COLORADO
Division of Reclamation, Mining and Safety
Department of Natural Resources

MINERALS PROGRAM INSPECTION REPORT
PHONE: (303) 866-3567

MINE NAME: Golden Wonder Mine	**MINE/PROSPECTING ID#:** M-1978-091-UG	**MINERAL:** Gold	**COUNTY:** Hinsdale
INSPECTION TYPE: Monitoring	**INSPECTOR(S):** Lucas West	**INSP. DATE:** October 11, 2021	**INSP. TIME:** 10:15
OPERATOR: LKA International Inc.	**OPERATOR REPRESENTATIVE:** Kye Abraham	**TYPE OF OPERATION:** 110d - Designated Limited Impact

Photo Three: View north, showing the preferential flow path that the mine water discharge has established as a result of the plugged conveyance pipe that would deliver the mine water to the collection pond. Visible evidence of impaired water quality was observed.

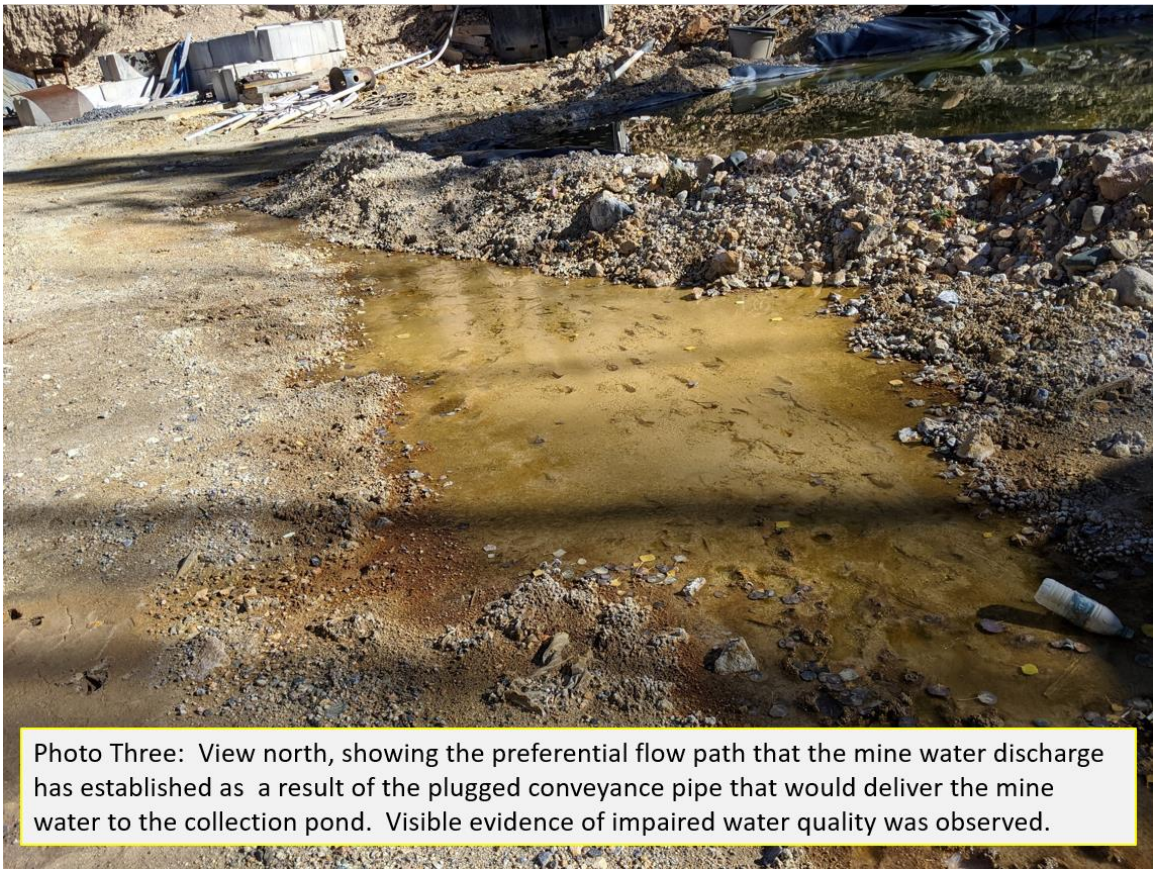
PROBLEM/POSSIBLE VIOLATION: Possible Violation: Water quality monitoring and treatment operations at the site are not operating in accordance with the approved permit held by DRMS and is in various states of disrepair. Specifically, the mine water conveyance system designed to deliver the portal discharge to the Mine Water Pond has become obstructed allowing untreated mine water to bypass the mine water pond and enter the lined stormwater Pond. In addition, the mine water pond and stormwater ponds are at maximum capacity with no freeboard to allow for additional inputs from stormwater precipitation or the mine water. In accordance with Technical Revision 4, mine water is to be collected, treated and discharged via the sump system in Deadman Gulch. Also, stormwater is to be impounded, sampled, treated if necessary and discharged via the sump system in Deadman Gulch. The sump has become silted in with sediment and is inoperable at this time.

CORRECTIVE ACTIONS: The above listed Possible Violations require immediate action. The Operator shall, within 30 days of the date of this report, make any and all necessary repairs to the water treatment system and resume water treatment and discharge operations in accordance with the approved DRMS AND WQCD Permit. The Operator shall comply with all monitoring and reporting requirements of the applicable permits, treat and discharge all affected waters including the water contained within the mine water pond and stormwater ponds. The mine water pond should be treated and discharged such that sufficient freeboard is established to receive inputs from precipitation and mine discharge water to sustain the system during the winter months. In addition the conveyance system that delivers mine water discharge to the mine water pond should be repaired and reestablished to prevent mine water discharge from bypassing the water treatment system. The stormwater pond should be monitored, treated if necessary and discharged such that sufficient freeboard is established to receive inputs from storm water and snowmelt during the winter months. Please note that stormwater treatment and discharge if necessary may be required throughout the winter months to ensure compliance with applicable water quality regulations. The Operator shall also make repairs to the stormwater control structures as discussed on site immediately. Resumption of treatment operations should be conducted immediately and written documentation and photo documentation shall be submitted to the Division within 30 days of the date of this report. In addition the Operator shall provide to the Division a written narrative supported by photo documentation, detailing the repairs that have been made, a summary of the volume of water treated, and discharged including the water quality reports detailing the quality of the discharge water to ensure compliance with the applicable permits. This report should be provided to the Division within 60 days of the date of this report.

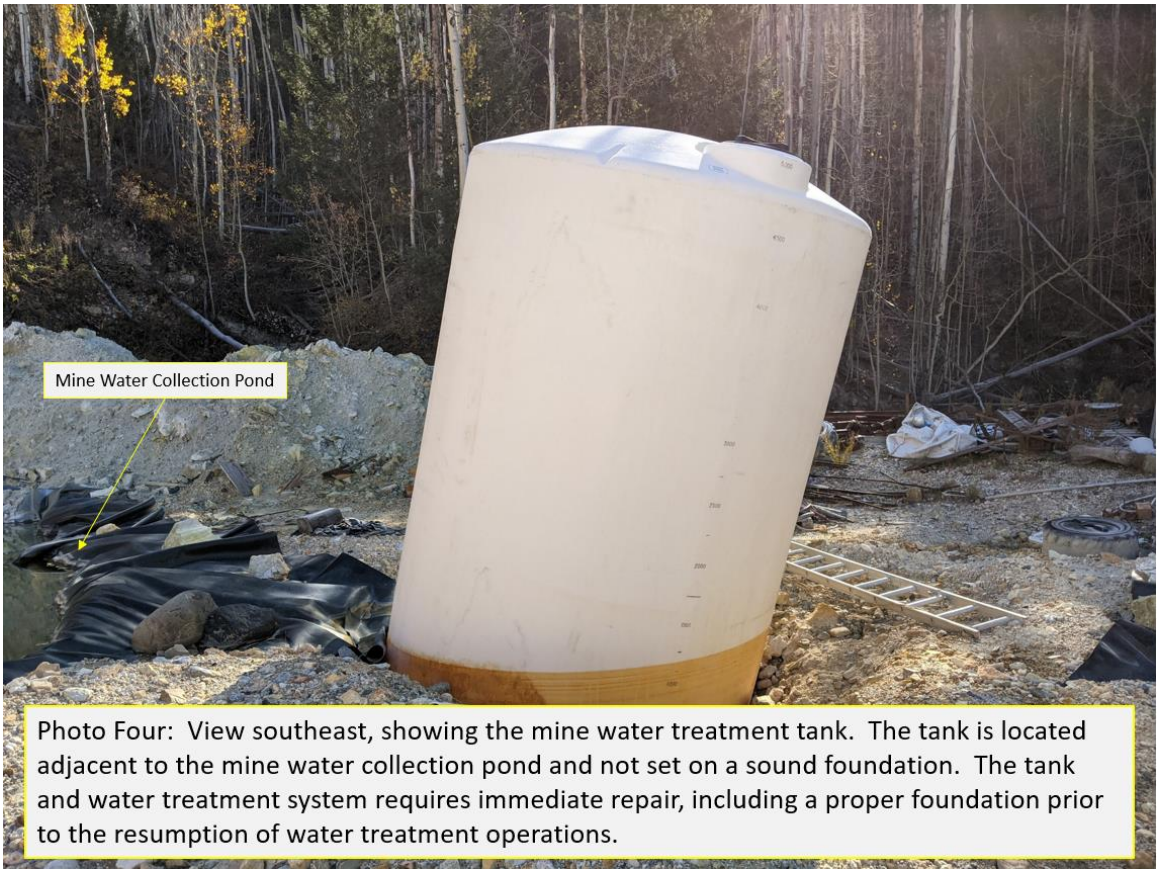
Located adjacent to the mine water collection pond, is the mine water treatment tank shown in Photo Four. The mine water treatment system was addressed in Technical Revisions 3 and 4. The tank was empty at the time of the inspection, and shows evidence of improper placement. The tank does not sit on a competent foundation, and has settled during use, resulting in a significant lean that will need to be corrected prior to use. Visual evidence of impaired water quality was also observed on the tank in the form of red staining around the base of the tank. Mine water treatment is achieved by the addition of chemicals to achieve water quality standards, and discharge via PVC pipe to the collection sump located down gradient in Deadman Gulch. The sump was observed, and can be seen in Photo Five. The sump acts as a collection and mixing pond for mine discharge water, as well as waters from Deadman Gulch that have been routed around the disturbed area. The sump contained no water, and has become silted in. As part of the Corrective Actions required

Photo Four: View southeast, showing the mine water treatment tank. The tank is located adjacent to the mine water collection pond and not set on a sound foundation. The tank and water treatment system requires immediate repair, including a proper foundation prior to the resumption of water treatment operations.

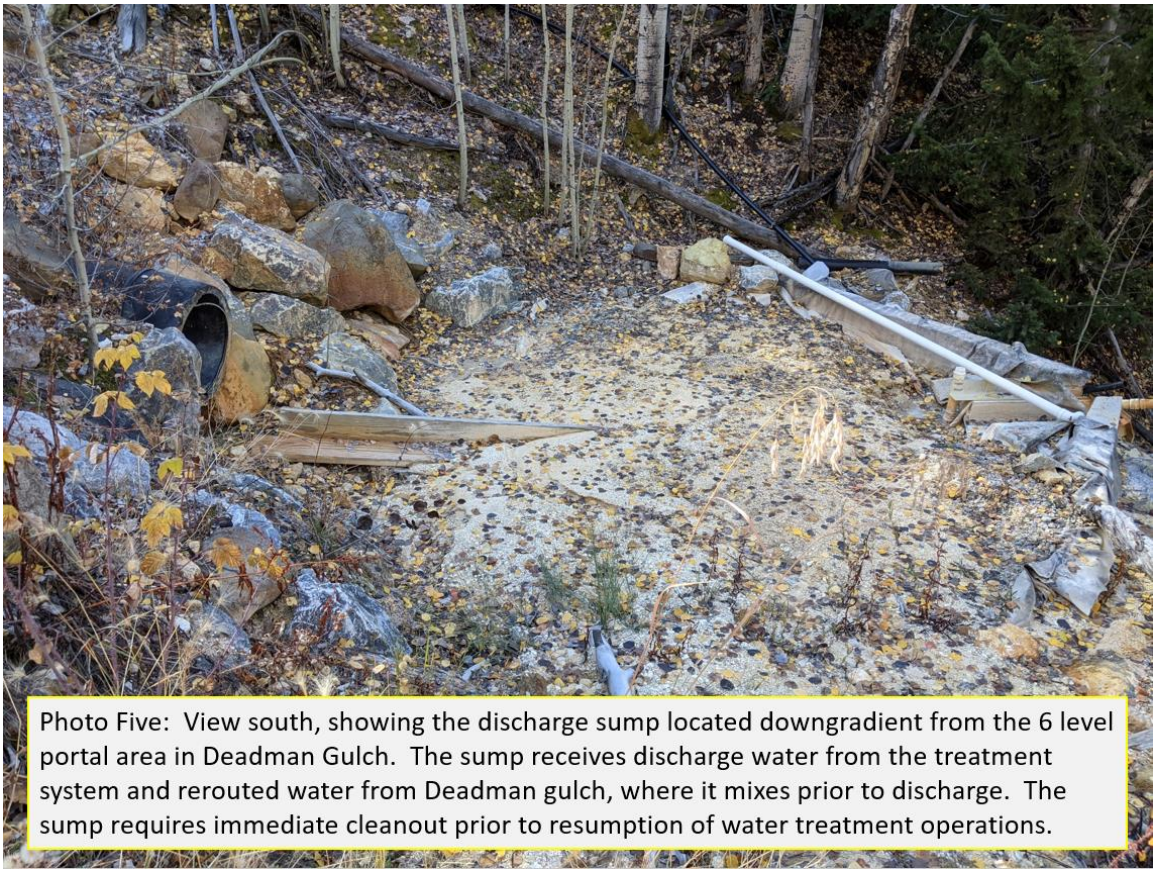
Photo Five: View south, showing the discharge sump located downgradient from the 6 level portal area in Deadman Gulch. The sump receives discharge water from the treatment system and rerouted water from Deadman gulch, where it mixes prior to discharge. The sump requires immediate cleanout prior to resumption of water treatment operations.

under this report, the Operator shall immediately mobilize any and all personnel and equipment necessary to clean out the sump and restore it to a proper functioning condition prior to use.

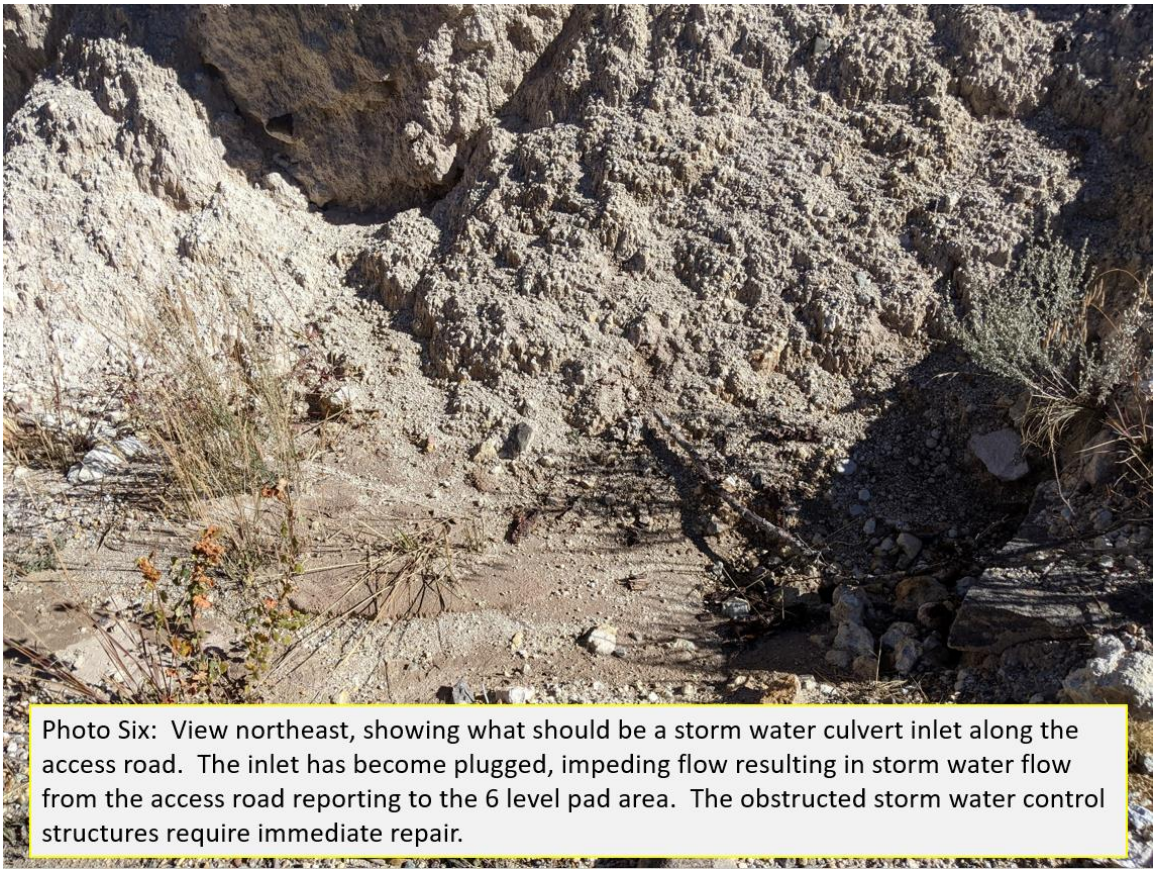
Stormwater flows are controlled along the access road leading to the 6 level portal area by way of a bar ditch and periodic culverts before reaching the pad. Three culverts have been installed along the access road, two of which are completely plugged preventing flow. An example of the plugged culverts can be seen in Photo Six. The two culverts that are plugged are the two closest to the 6 level portal area. The plugged culverts result in stormwater flowing down the access road, across the portal pad and into the stormwater collection pond. No evidence of significant erosion was noted as a result of the plugged culverts, however it has resulted in increased stormwater storage in the stormwater collection pond. The pond can be seen in Photo Seven and similar to the mine water collection pond is lined with a synthetic liner. It too, appears to be at or near its maximum capacity, additional stormwater inputs will result in unmanaged discharge into Deadman Gulch. Onsite discussions with the Operator indicated that repairs to the stormwater controls could wait until the spring of 2022, however given the interaction of the stormwater controls with the mine water and stormwater ponds on site, repairs to the stormwater control structures should be conducted immediately. Please note that stormwater monitoring, treatment if necessary and discharge may be required through the winter months to ensure compliance with Colorado Water Law which requires impounded storm water be released within 72 hours.

Photo Six: View northeast, showing what should be a storm water culvert inlet along the access road. The inlet has become plugged, impeding flow resulting in storm water flow from the access road reporting to the 6 level pad area. The obstructed storm water control structures require immediate repair.

Photo Twelve: View southwest, showing the various drill core boxes left onsite from drilling operations on the Operators nearby NOI. This has been cited as a problem and requires immediate cleanup.

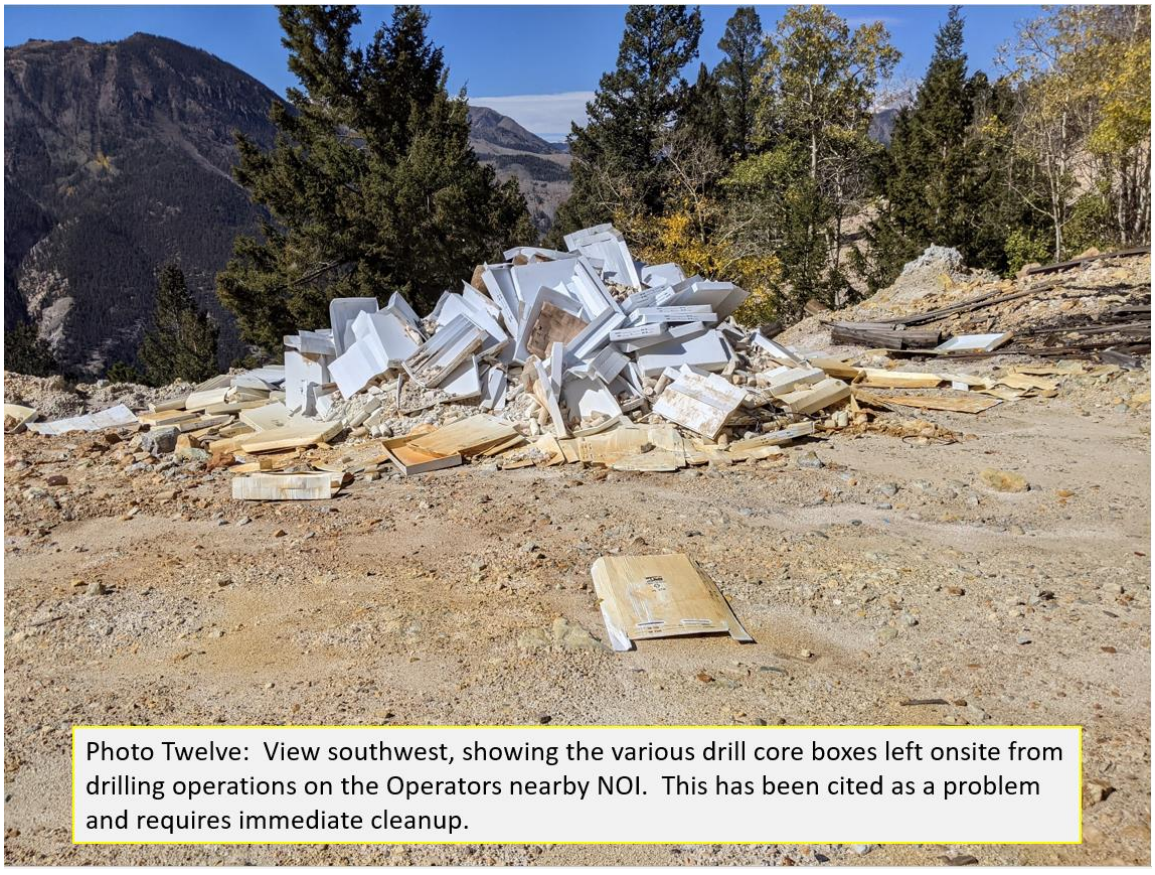
The 3 level portal area has been used as a staging area for drilling operations associated with the Operator's currently held NOI, file no P-2018-010. As a result of using the area for staging, a significant pile of cardboard drill core boxes were left unsecured on site. The main pile, seen in Photo Twelve has been exposed to the elements and dispersed across the site and surrounding areas by wind. Photos Thirteen and Fourteen show the scattered boxes that were observed. This is being cited as a problem for failure to dispose of refuse in a manner that controls unsightliness or deleterious effects of such refuse pursuant to C.R.S. 34-32.5-116(4)(e). The Operator shall conduct cleanup and removal of all associated trash and debris, specifically the cardboard drill core boxes at the 3 level. Cleanup efforts should be conducted within 60 days of the date of this report, and the Operator shall provide photo documentation that all items have been removed from the site. Photo documentation should be received by the Division no later than **Monday December 13, 2021**.

INSPECTION TOPIC: other
PROBLEM/POSSIBLE VIOLATION: Problem: Trash and refuse was noticed on the site. This is a problem at this time for failure to dispose of refuse in a manner that controls unsightliness or deleterious effects of such refuse pursuant to C.R.S. 34-32.5-116(4)(e). A large amount of drill core boxes were observed around the 3 level portal area. The boxes have been left unsecured, and dispersed across the site and the surrounding area.
CORRECTIVE ACTIONS: The operator shall submit a written notice to the Division with photo documentation, that the trash has been removed from the site by the corrective action date.
CORRECTIVE ACTION DUE DATE: 12/13/21
